**FINAL PROPOSED 2023
AMENDMENT**

**2015 BELLEAYRE MOUNTAIN SKI
CENTER UNIT MANAGEMENT PLAN**

OLYMPIC REGIONAL DEVELOPMENT AUTHORITY

Tree Counts

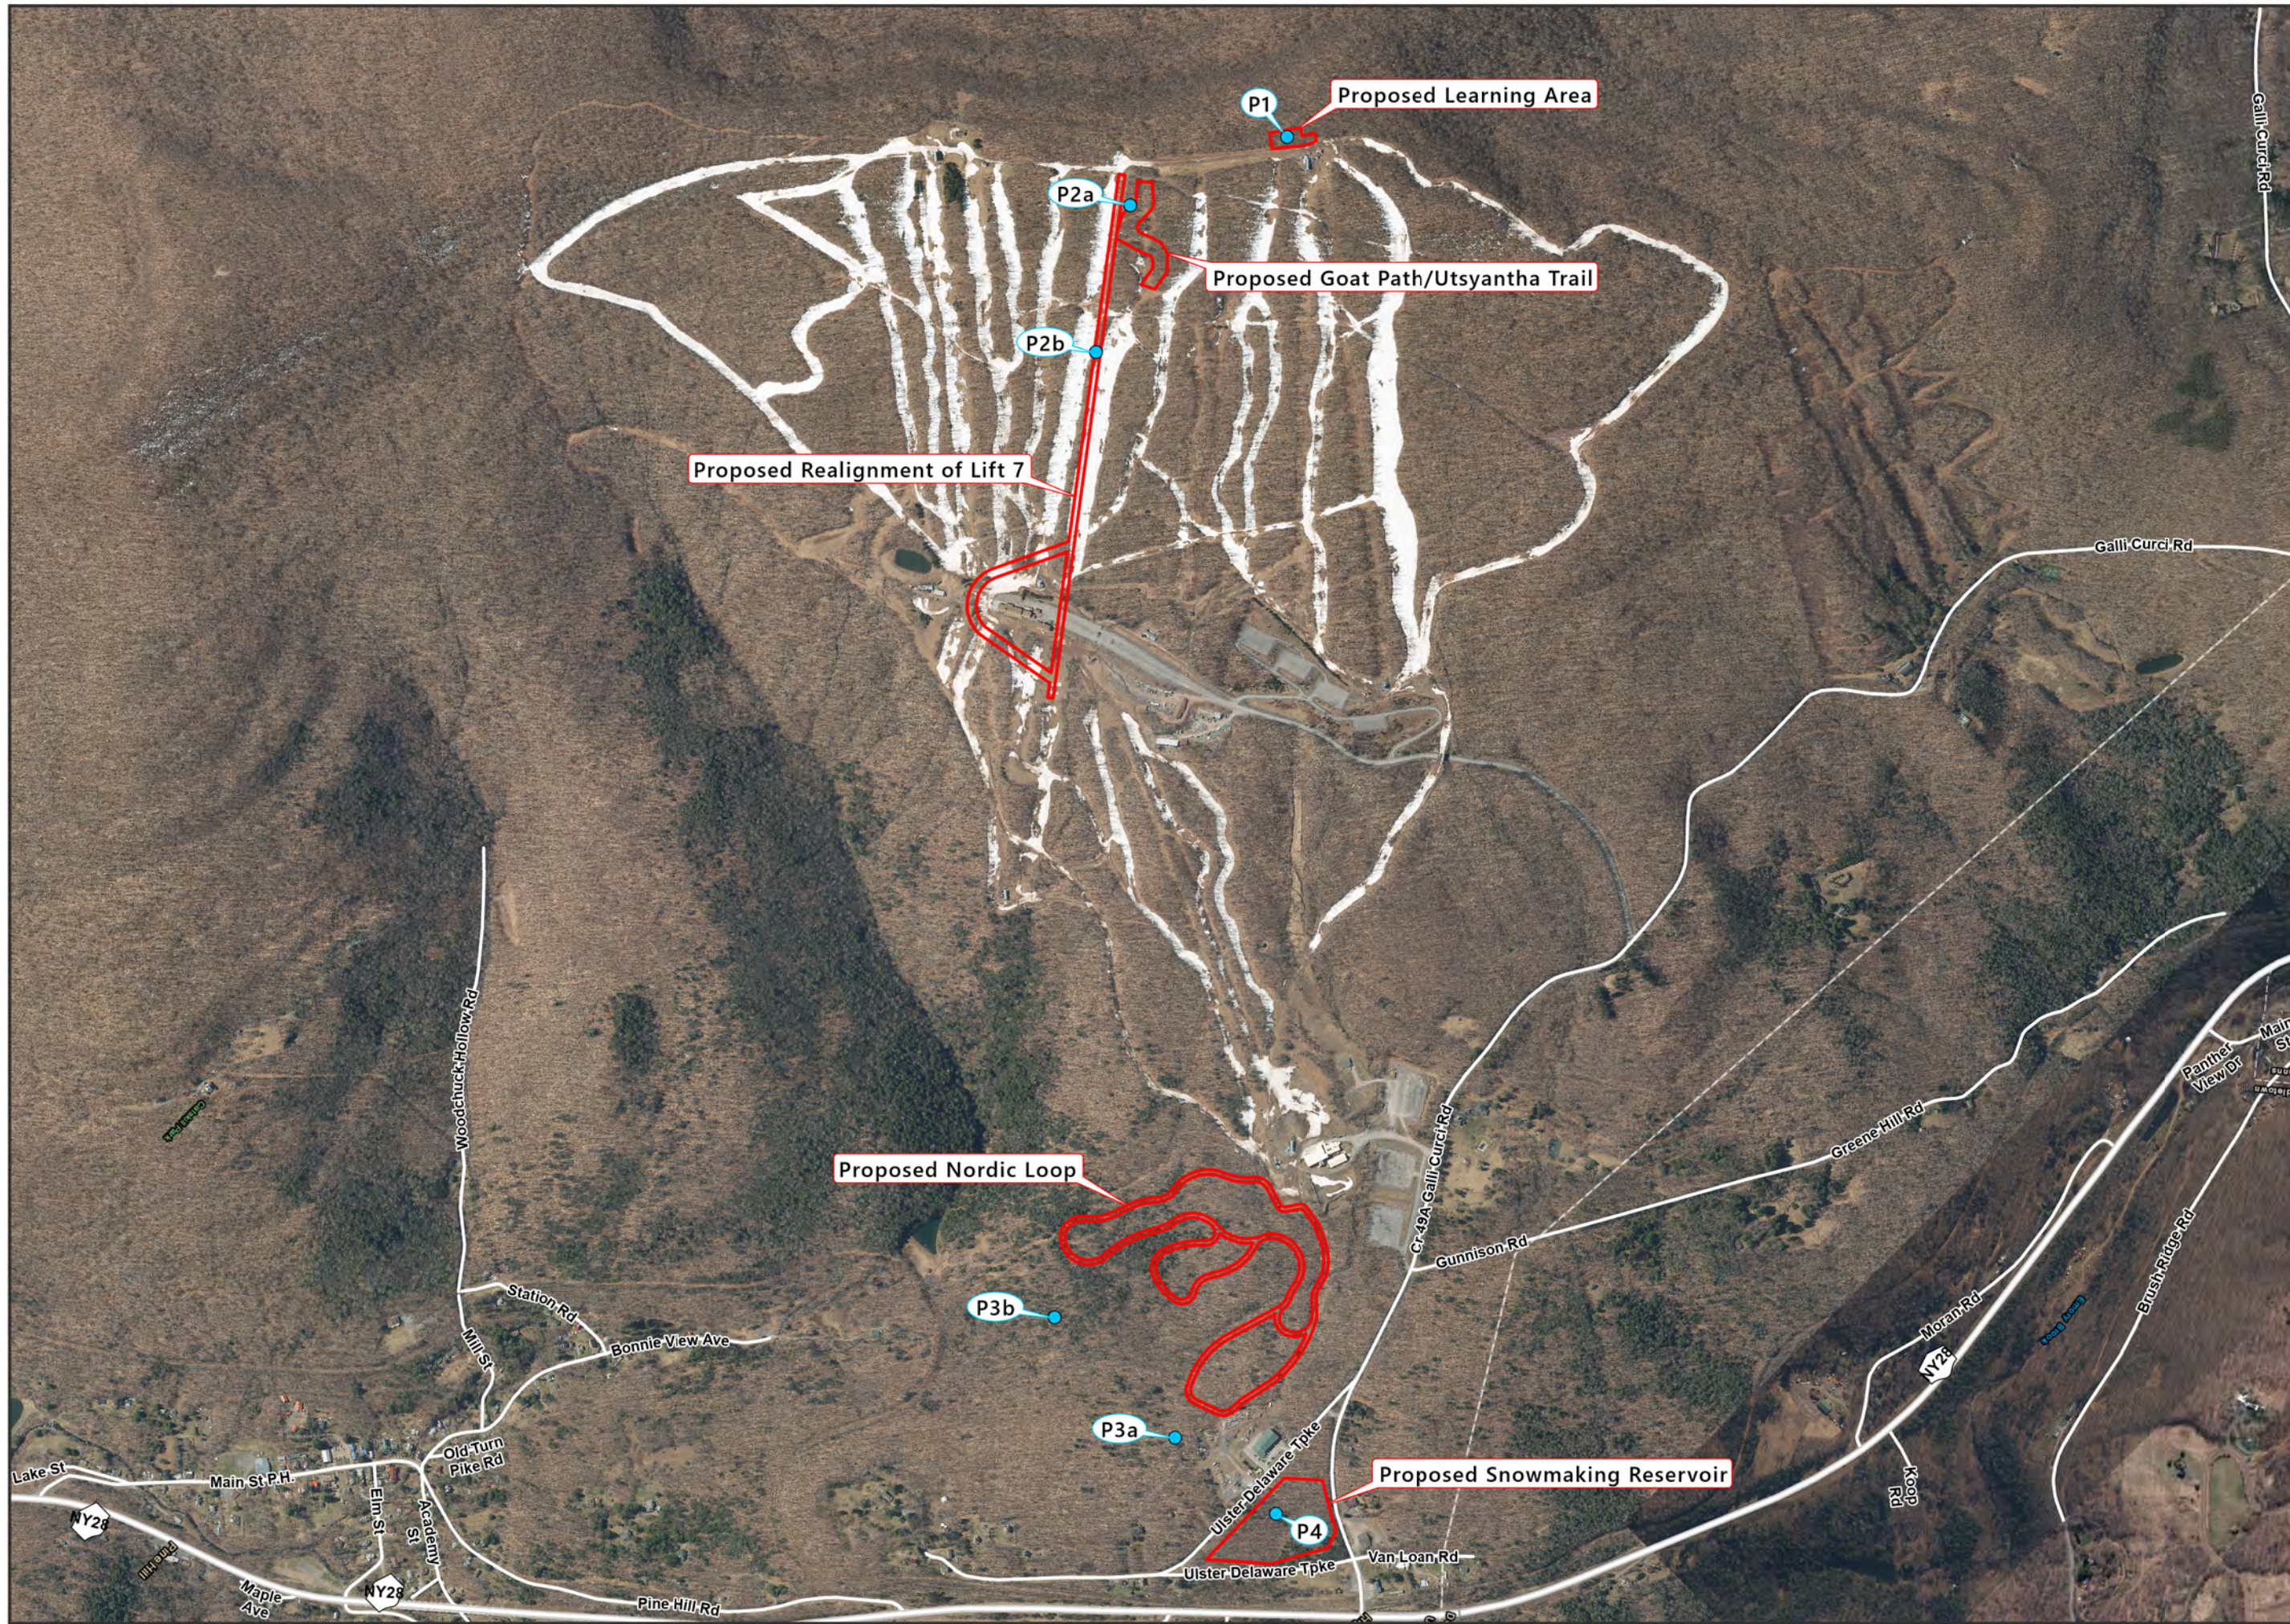
Comment: The analysis of tree counts and tree cutting in Exhibit 3 is difficult to read in an 8 1/2 by 11 inch format.

Response: *Yes, this proposal requires tree cutting, but it will not limit future tree cutting within the ski area. Tree counts have been provided in the UMPA as Exhibit 3.*
